Mesa 500-kV Substation Project CPUC Minor Project Change Form

Report No.: 03

RE: Mesa 500-kV Substation Project – Minor Project Change No. 3 Request, CPUC Data Request Memorandum

**Re: Mesa 500-kV Substation Project – Minor Project Change No. 3 Request,
SCE Responses to CPUC Data Requests #1 and #2**

FIGURE 1
MESA 500KV SUBSTATION
 REVISED KOP, NEW POLE, AND
 LINE LOCATIONS
 FOR MINOR PROJECT CHANGE THREE

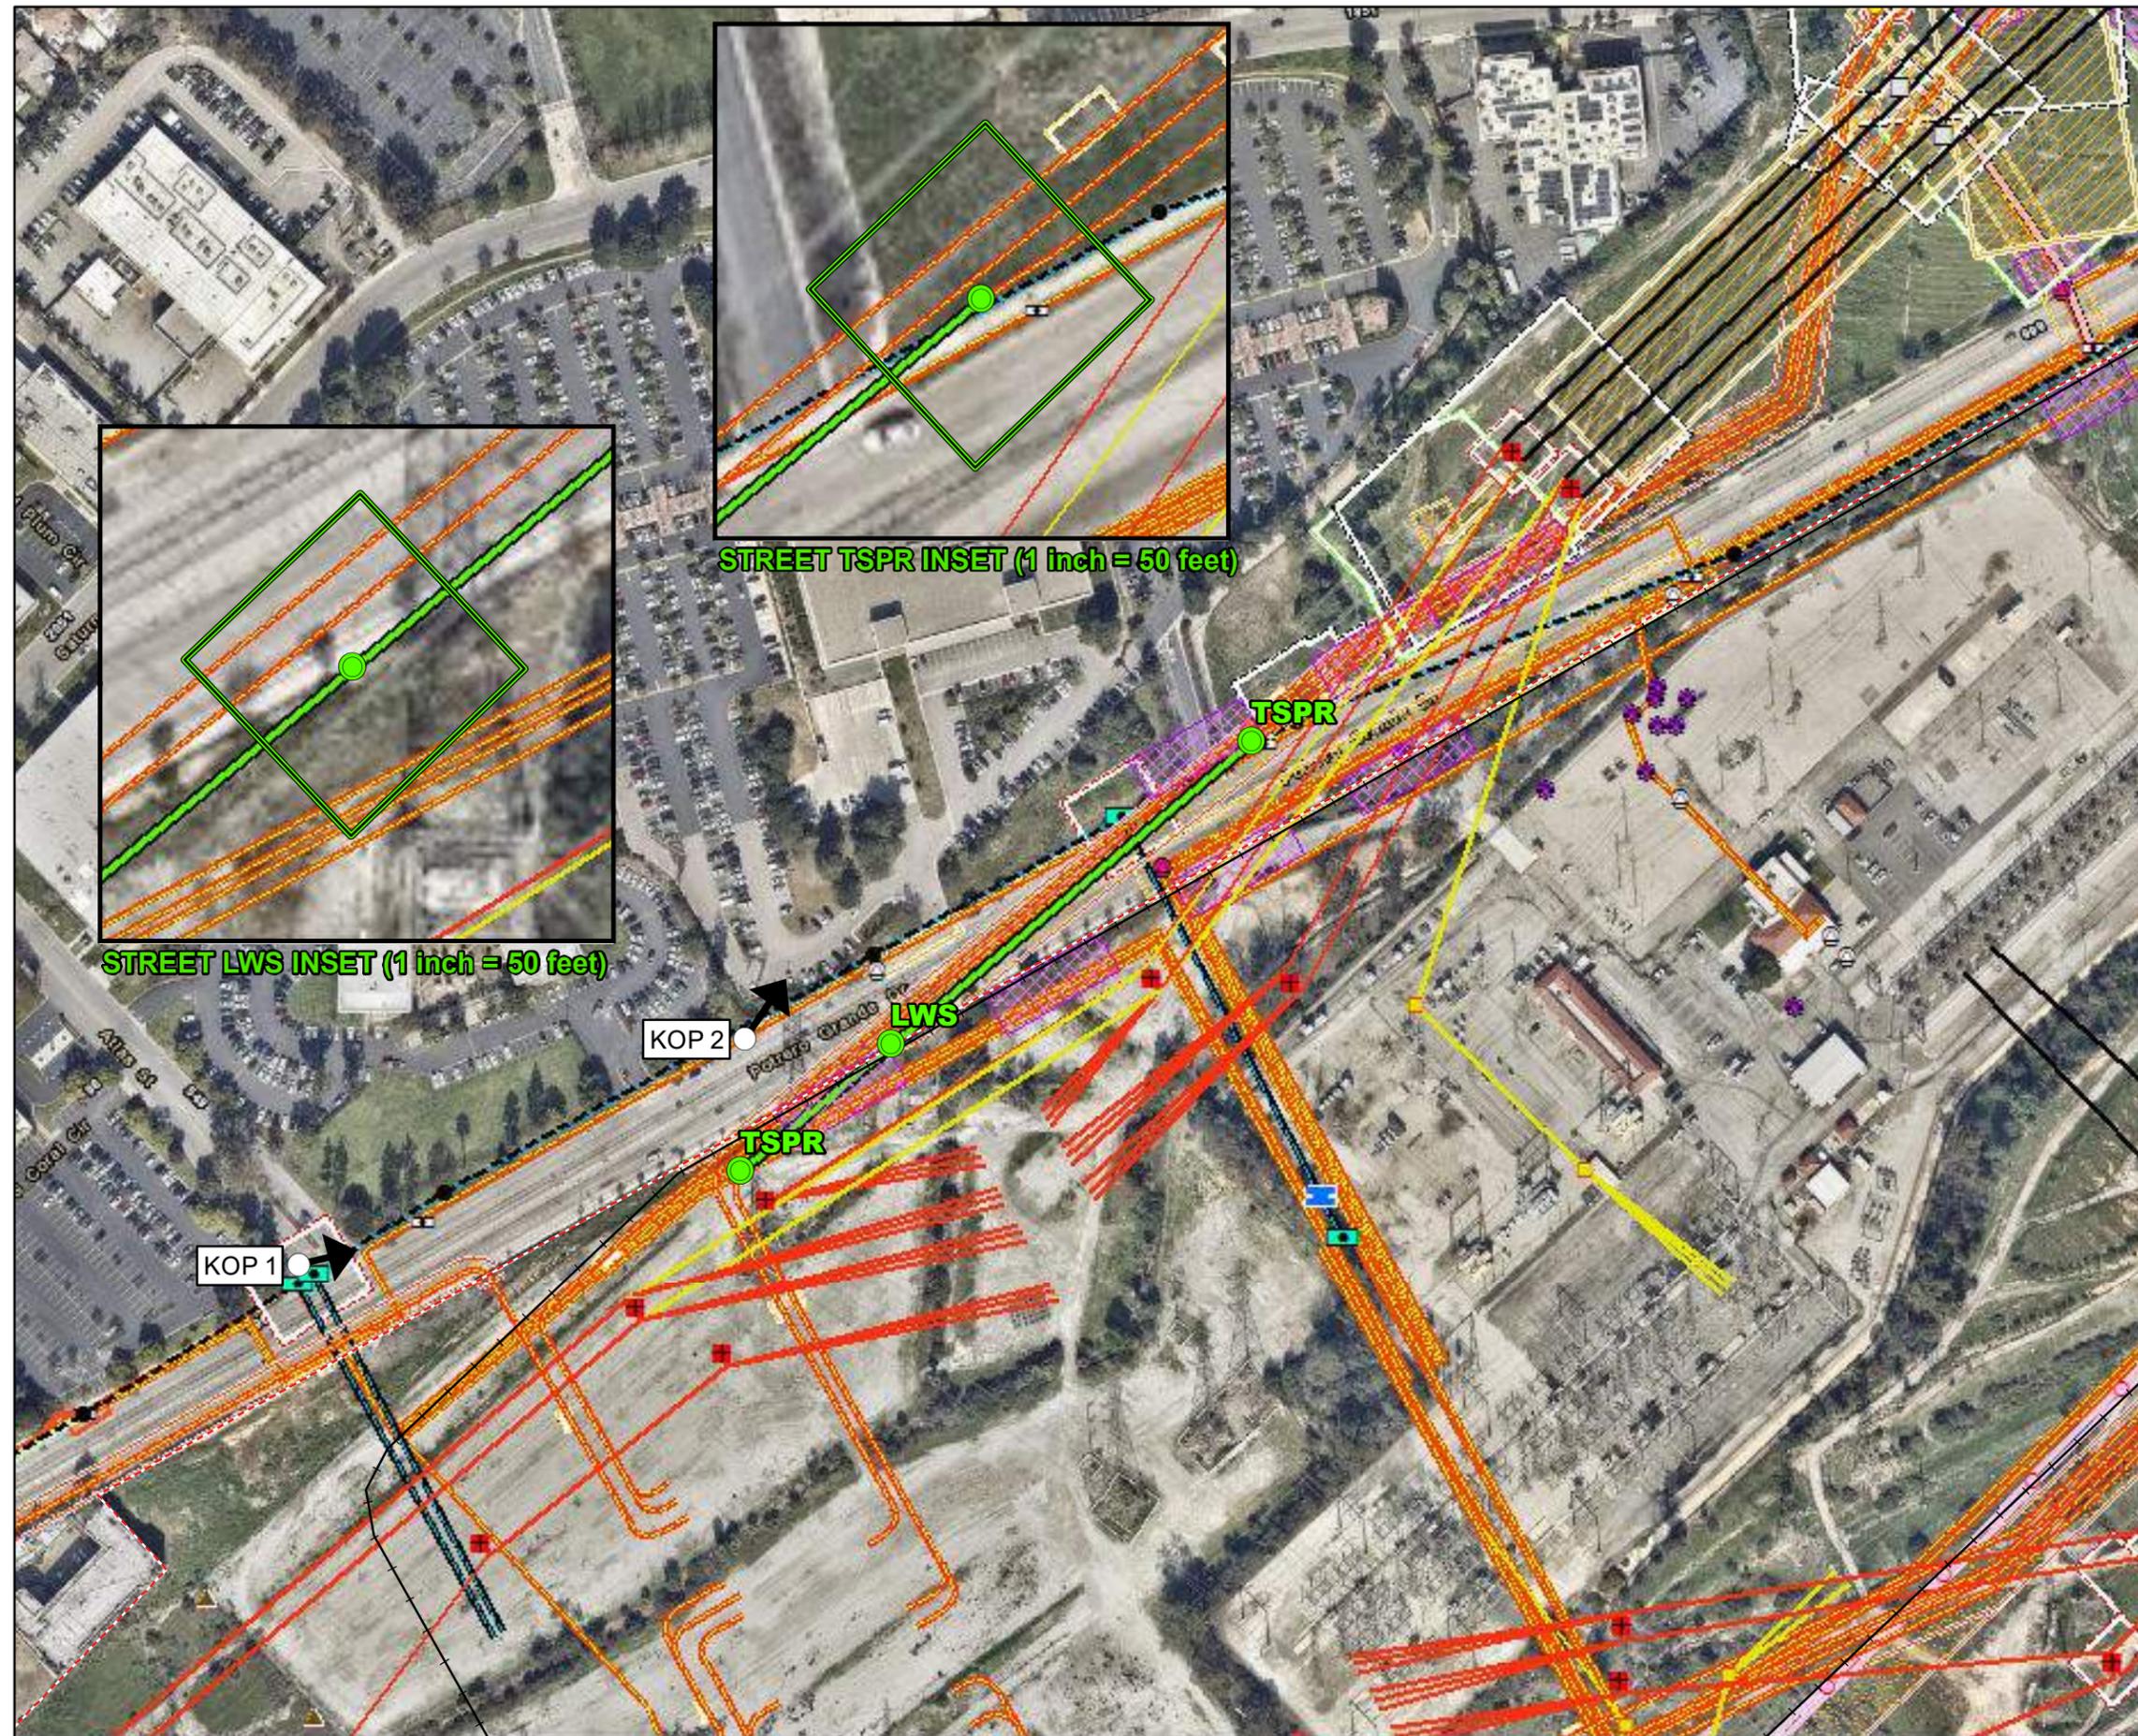
1. Provide a detailed map showing the exact locations of the proposed new TSP and LWS installations (and overhead lines) associated with MPC No. 3 in relation to the currently approved project and existing public infrastructure (e.g., streets and sidewalks). Include the locations of all proposed permanent and temporary disturbance/work areas, and provide the area for each (e.g., acres or square feet). Also provide the heights of the three proposed poles. The MPC No. 3 Request references a Figure 1, but the figure was not included.

SCE previously provided a figure (MPC3 Figure 1.pdf) showing the location of the new proposed structures along with the previously approved project elements, via email on January 9. We included a work area around the two new proposed structures that fall outside the substation, on the north and south sides of Potrero Grande. Each of these work areas is 5,000 square feet, but mostly overlap with previously approved work areas. Also attached was a work order map (1097103_0.pdf) which shows each of the structures (1, 2 and 3) and their pole heights. FYI, the visual simulations provided with our initial submittal were generated from the pole height information on this work order map.

SCE Pole Work Order Map
1097103_0

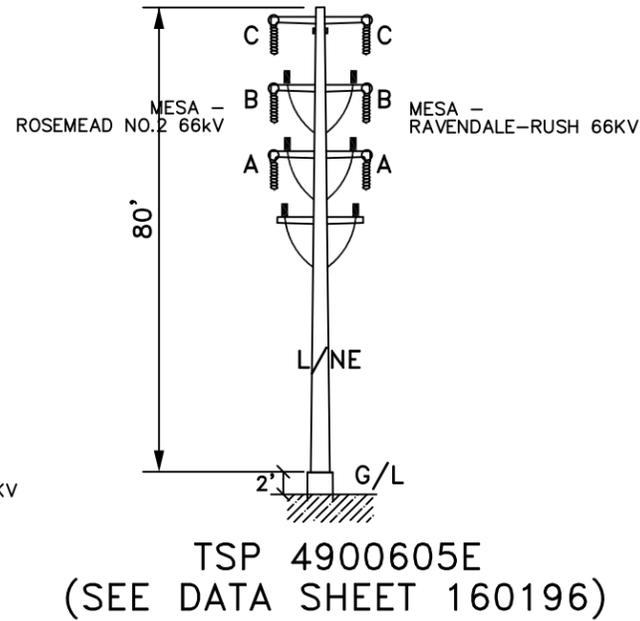
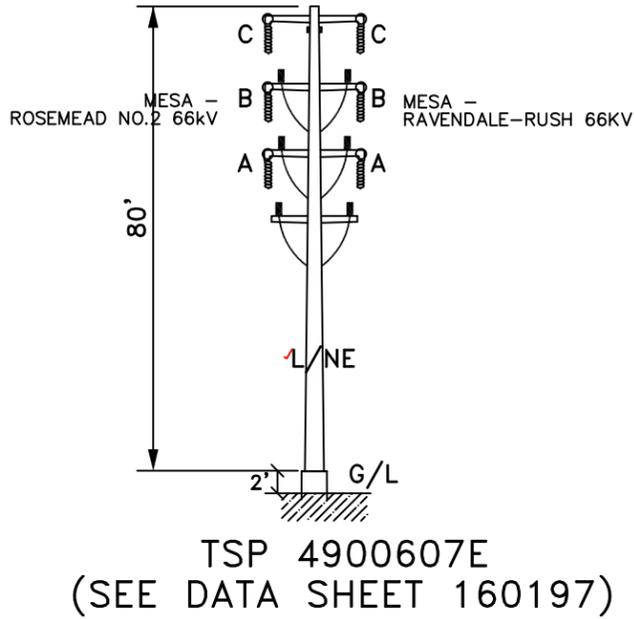
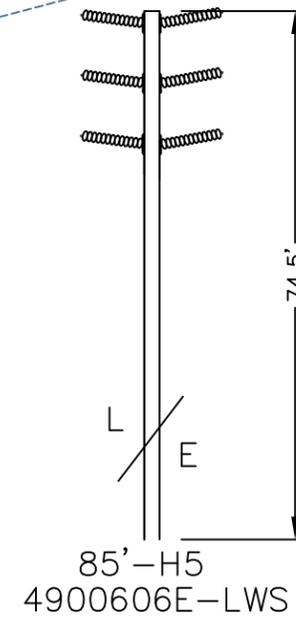
4. Please provide justification for placing the LWS pole located along the southern side of Potrero Grande Drive between the sidewalk and the substation wall, rather than within wall. The proposed location may have small impacts the aesthetic quality of the vegetation/plantings along Potrero Grande Drive. Is there a reason why the LWS couldn't easily be placed within the wall to avoid potential impacts?

The placement of the LWS pole on the south side of Potrero Grande was determined by both the location of the TSP within the substation property, as well as the need to stay safely away from the nearest duct bank on the north side of Potrero Grande. Additionally, we need to meet “swing and rise” clearance requirements between the structures on both sides of Potrero Grande. Due to the long span, and the significant difference in elevation between Potrero Grande and

the substation surface, the LWS is required to help meet GO-95 ground clearance requirements as we cross Potrero Grande. If the LWS was located within the wall, much taller structures would have been required.
